S.N. 09/813,205
Art Unit 2862
Atty Dkt 10013284-1

REMARKS

FIG. 1

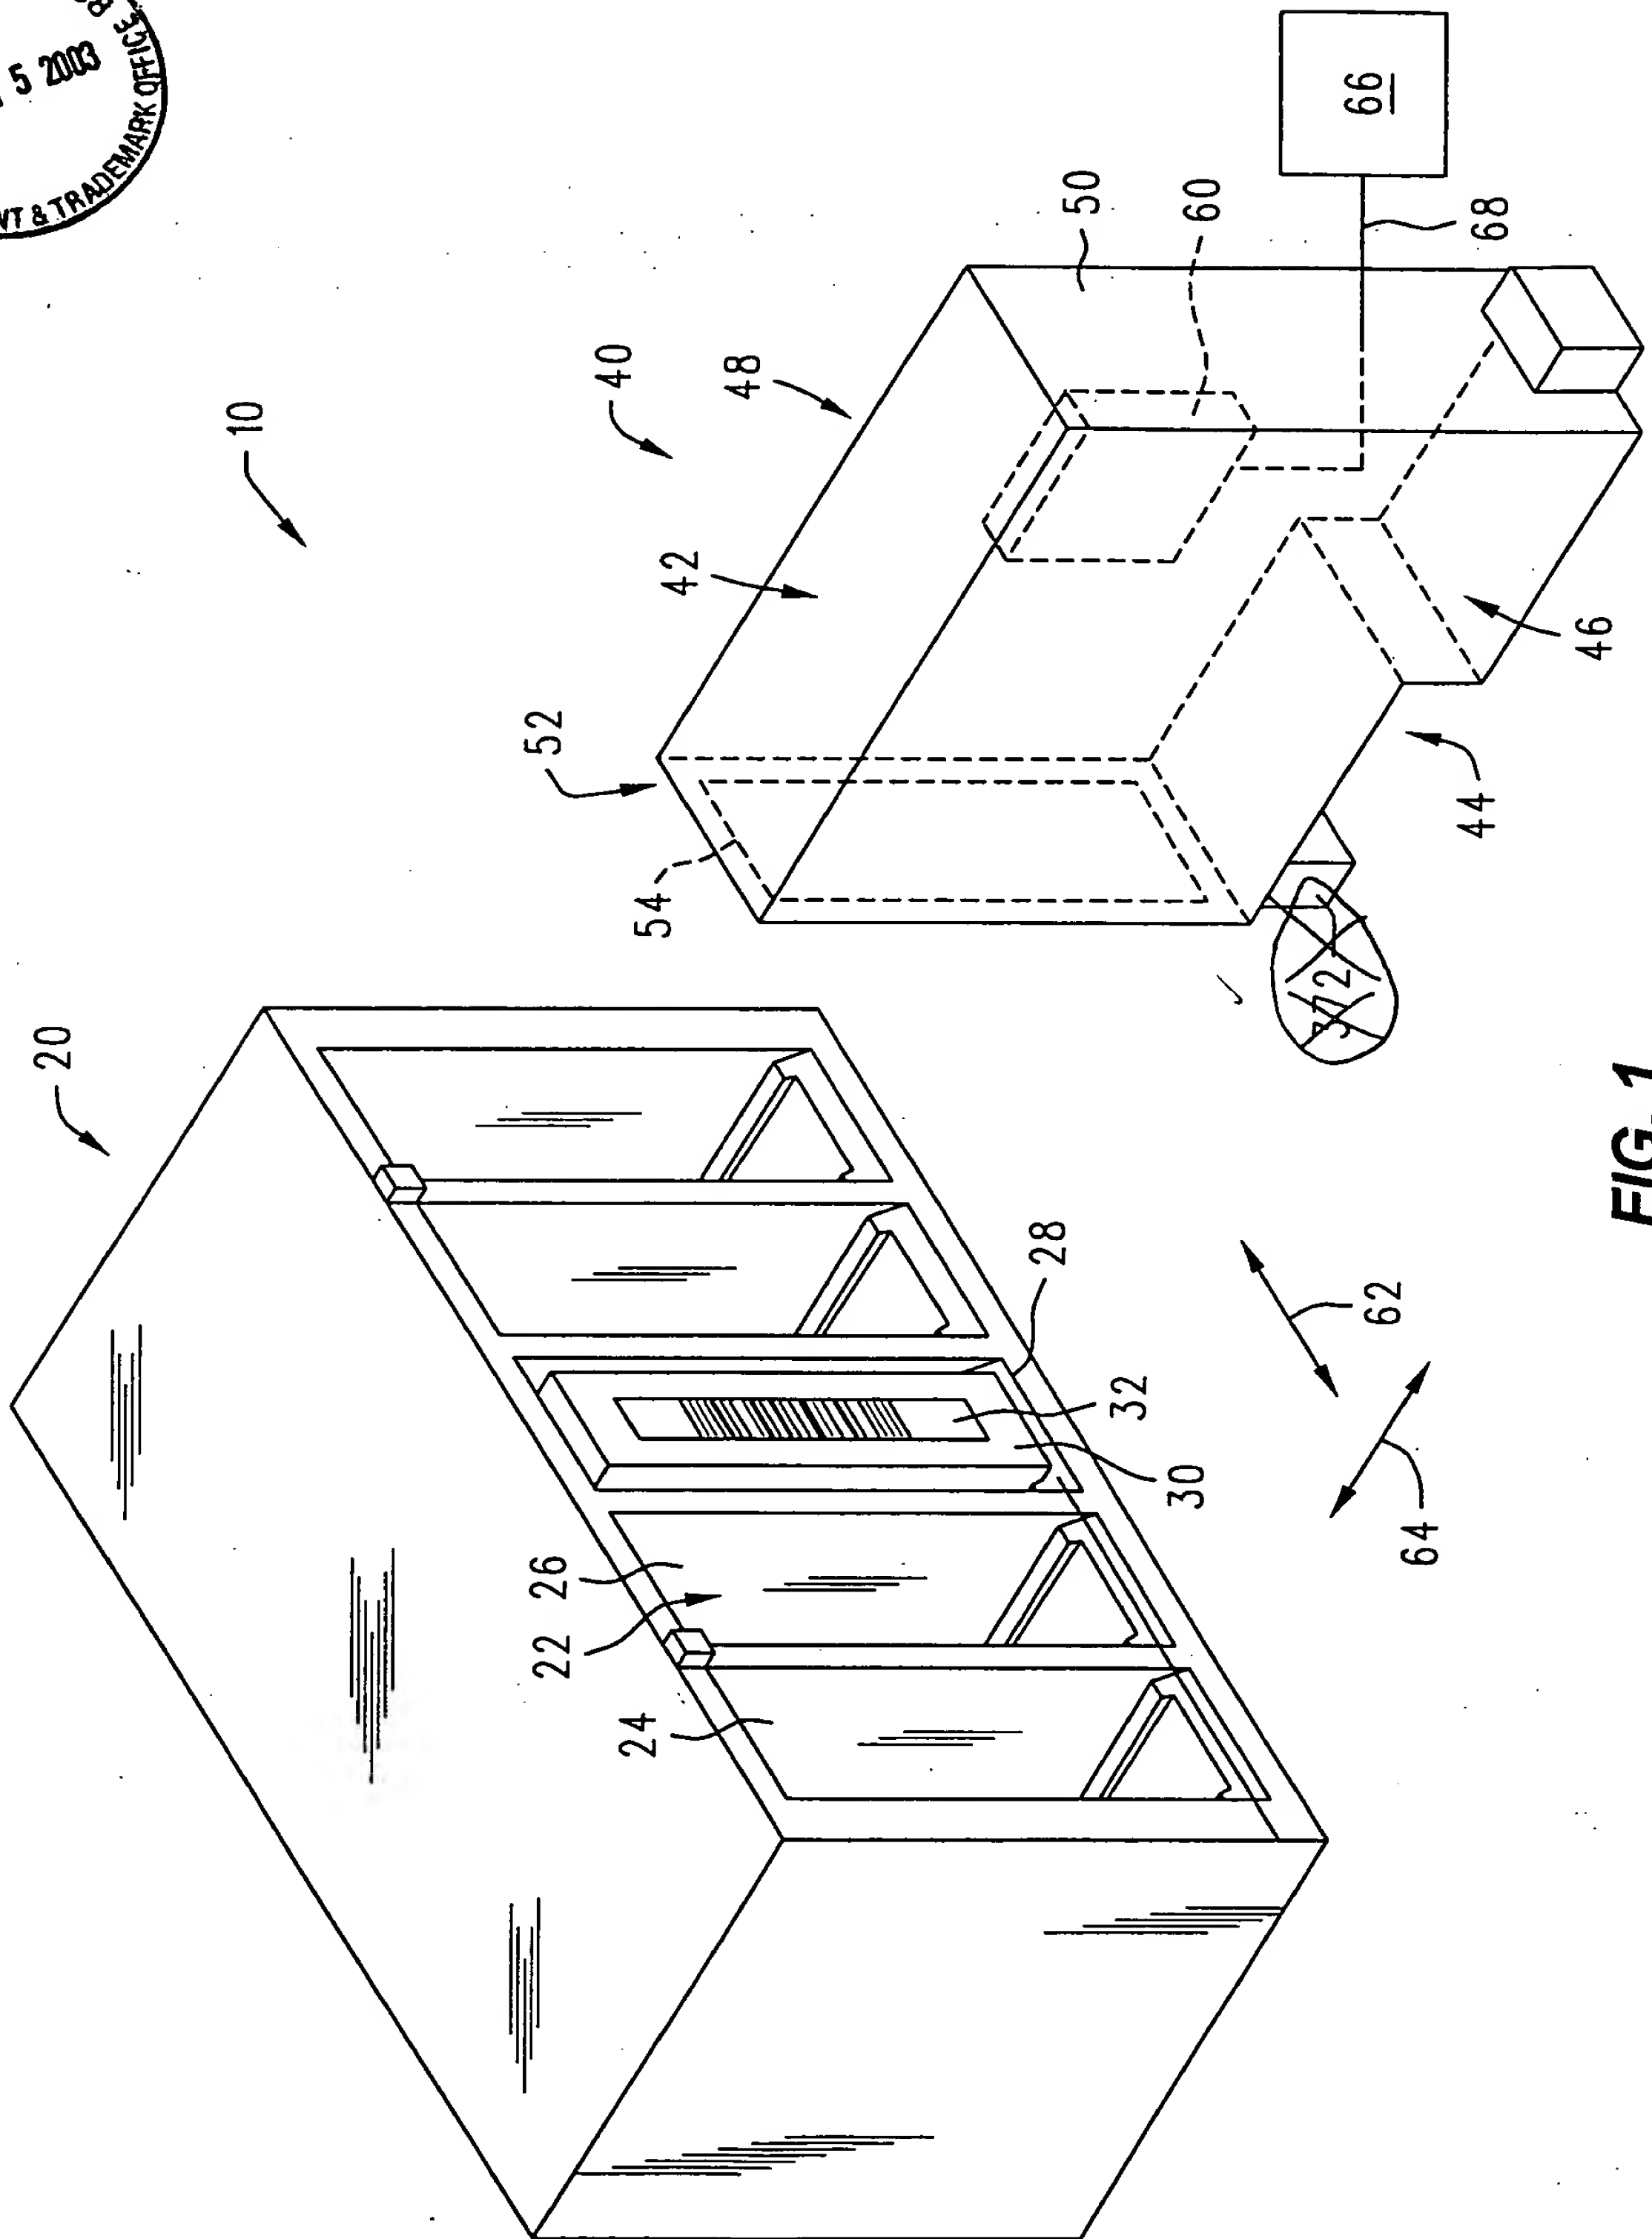
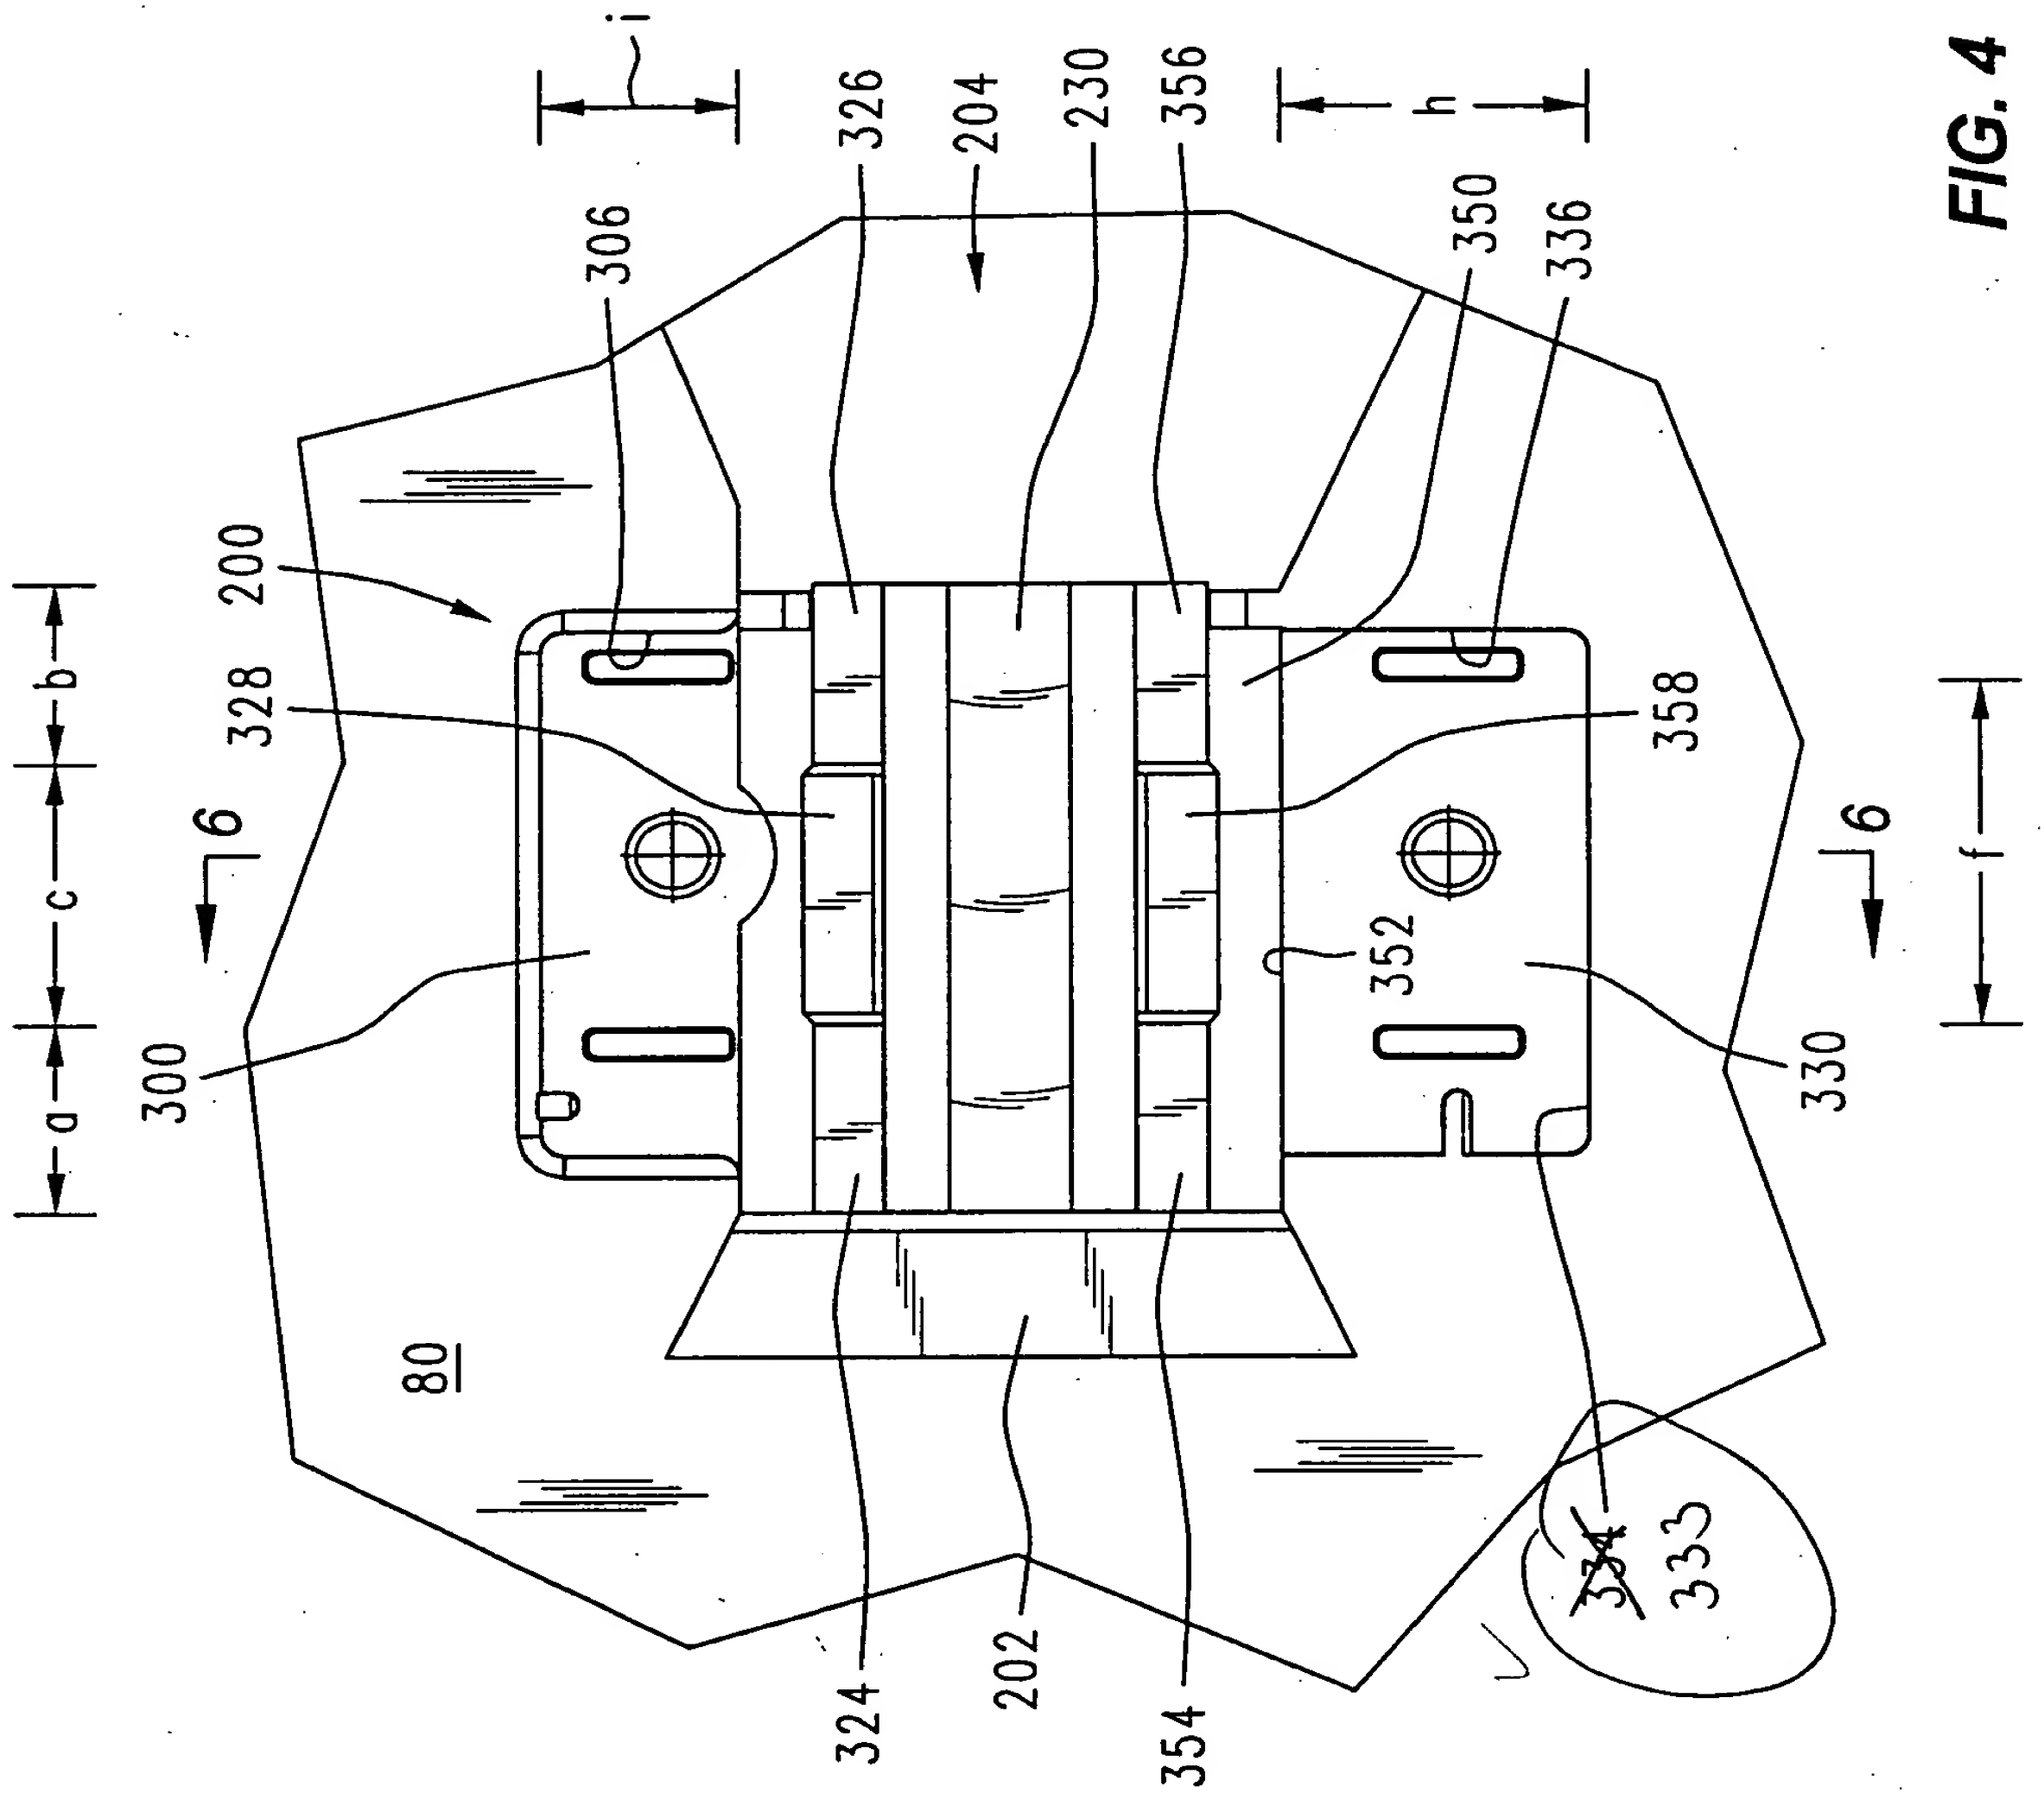
The Examiner notes that there is no mention in the written description of reference numeral 372 (appearing in Fig. 1). In response, applicants have amended Fig. 1 to remove reference numeral 372.
